Standish, ME Route 114 and Route 35 Road Safety Audit Report

Virtual RSA meeting: 11/16/2020, Field review: 12/8/2020

Issued on: 05/28/2021

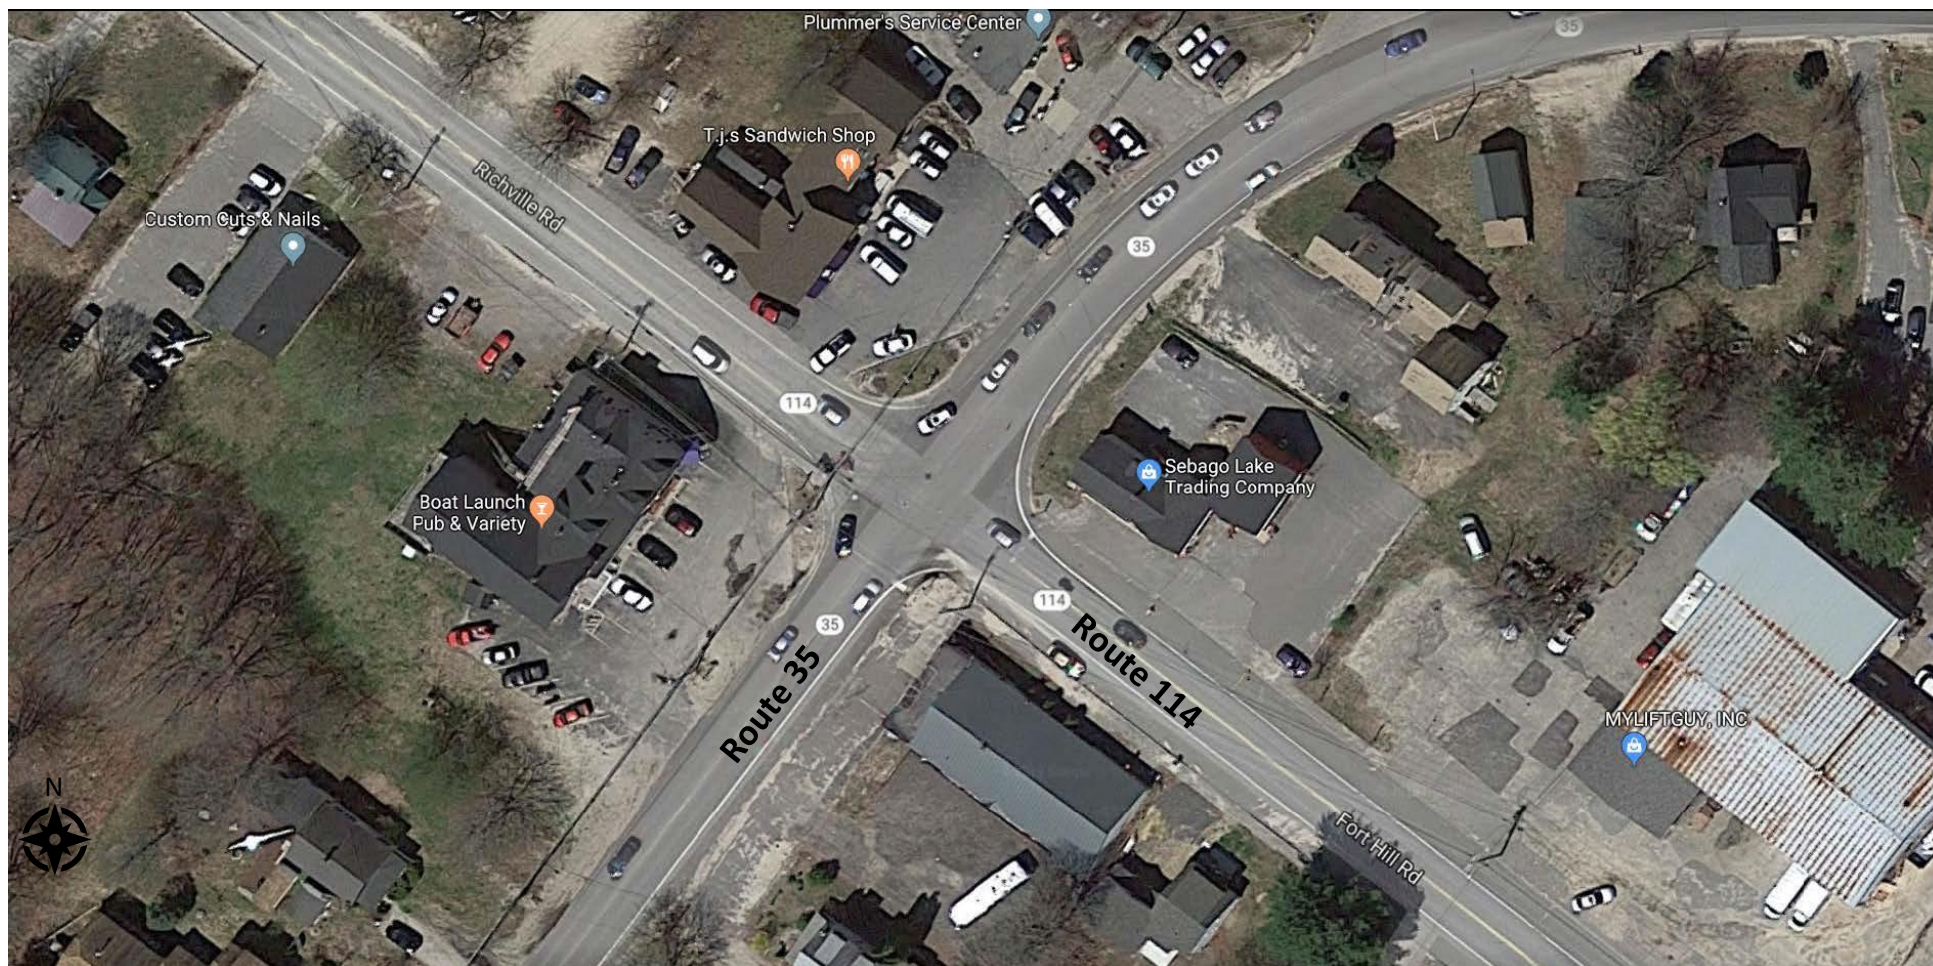
There were 17 crashes at this intersection. The crashes are relatively evenly split among the intersection approaches with two to four occurring on each. Many of the crashes (8 of the 11) at this intersection are failures to yield and running the stop sign.

As noted by the municipality, if volumes are high and traffic backs-up for a mile, driver's are likely impatient by the time they reach the intersection and do not wait their turn or run the stop sign. There are also numerous driveways near the intersection that drivers could use to bypass the intersection.

Intersection of Route 114 and Route 35

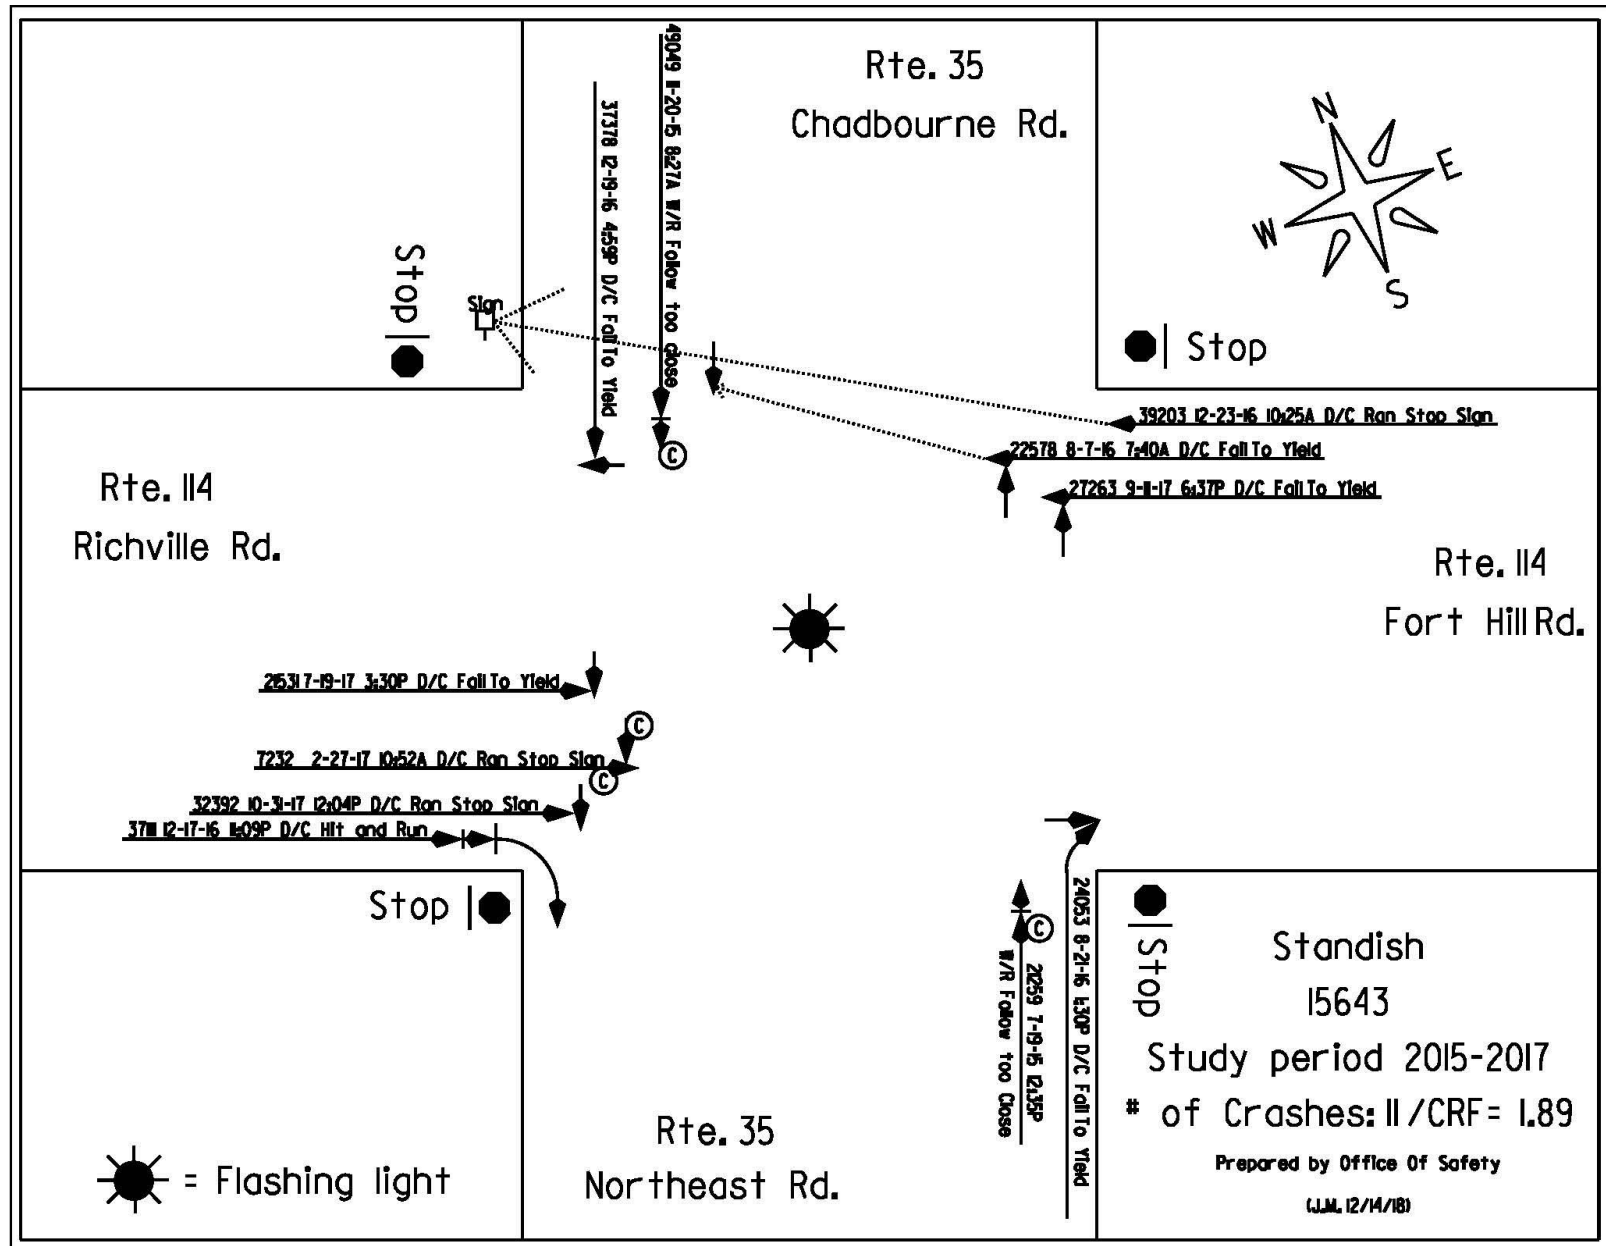
The crash data used for this assessment was based on 2015-2017 crash data. The following table summarizes the crash data for this location and also shows additional crashes from 2018. The crash diagram for this location is shown on the following page.
